Access Compliance Report Public Rights-of-Way (RR Crossings)

Intersection ID: 10034711	Main Street: POINDEXTER_DR	Location:	N/A
ADA ID: 5AAE159EE5B0	Overall Compliance: No	Severity Score:	0.0
Codes/Mitigation Info/Possible Solution		Field Measurements/Component Compliance

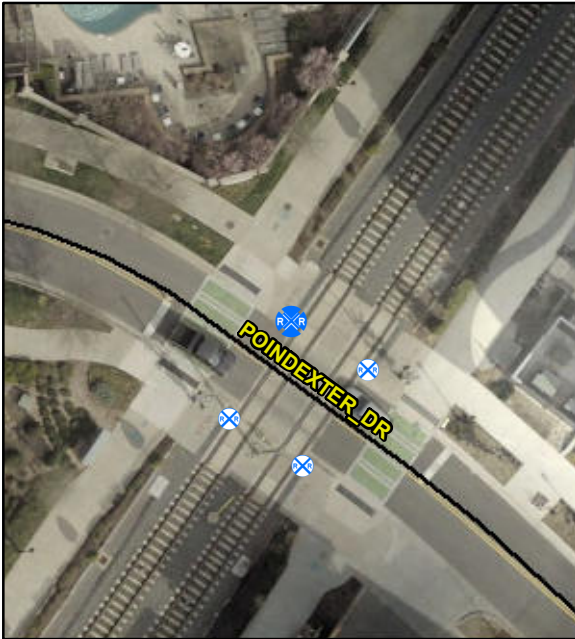
Remove & Replace Detectable Warning System. Provide Pedestrian Gate. Remove & Replace Walking Surface Adjacent to Rail.

Compliance	Description	Data
Yes	DWS Provided?	Yes
Yes	DWS Contrast?	Yes
Yes	DWS Width (in)	Yes
Yes	DWS Length (in)	24.0
No	DWS Offset (in)	12.0
No	Pedestrian Gate?	No
N/A	DWS Outside Gate?	N/A
N/A	Rail Type?	LightRail
No	Flangeway Gap (in)	3.0
Yes	Sidewalk Width (in)	61.0
